**Department of Energy**  
Washington, DC 20585

The purpose of this letter is to report the Department of Energy's (DOE) closure of the electrical safety issues at our Plutonium Finishing Plant (PFP) and at Hanford tank farms identified in your September 17, 2008, letter to the Assistant Secretary for Environmental Management.

# Richland Operations Office Plutonium Finishing Plant Closure Project

Electrical Safety DNFSB Briefing  
December 4, 2008

# Unprotected 291-Z 480-Volt Switchgear

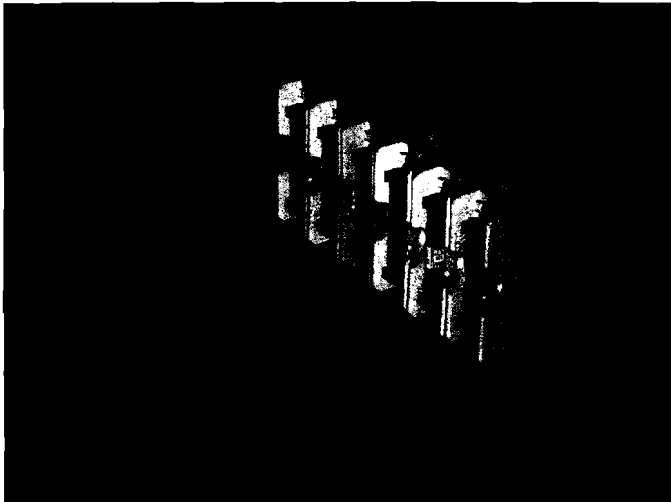
*Concern: Water could have leaked inside the switchgear. PFP agreed to evaluate the switchgear for damage.*

- **Switchgear inspected for damage, June 2008 (see photo's)**
  - No indications of damage were found
  - Water stains occurred several years ago during maintenance activities
  - Roofing inspections were conducted in July and November 2008
  - Removed water stains and painted to detect any future leaks, completed September 2008
  - Identified water leaks are being sealed (currently underway)

# Hydrogen Accumulation Hazard in 234-5Z Switchgear Battery Room

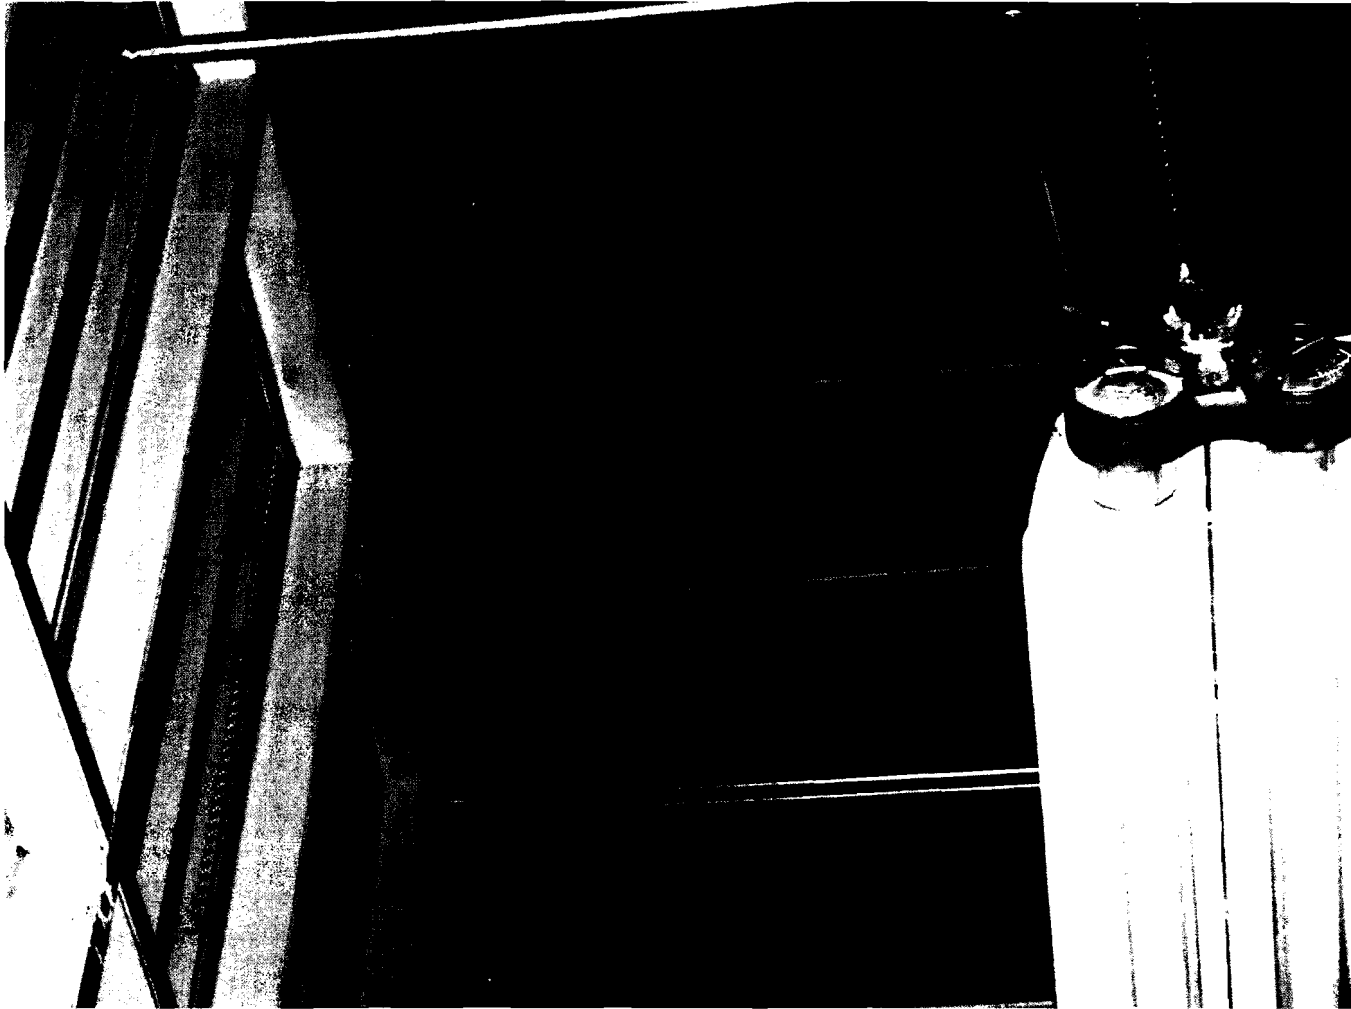
*Concern: PFP evaluate design modifications to prevent hydrogen accumulation in the space between the duct and the ceiling in room 269.*

- Hydrogen accumulation surveys, August 2008
  - No flammable gas detected
- Ventilation exchange rate survey, August 2008
  - High exchange rate
  - Active ventilation between duct and ceiling
- Low Hydrogen generation from batteries, per manufactures information
- Annunciation in 321 Control Room upon charging system failure
- Regularly scheduled checks of batteries (electrolyte, cell voltage, charging system, etc.) are conducted

**Modifications are not needed to prevent accumulation of hydrogen in room 269.**
